DEPARTMENT OF ECOLOGY

M E M O R A N D U M

To: Douglas Houck
From: Eric Egbers
Subject: Longview STP Class II Inspection

PARSHALL FLUME:

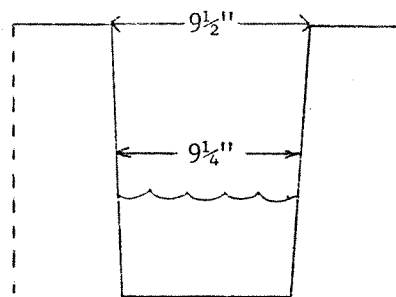
Throat walls seem to be the only walls not true. Others seem to be level.
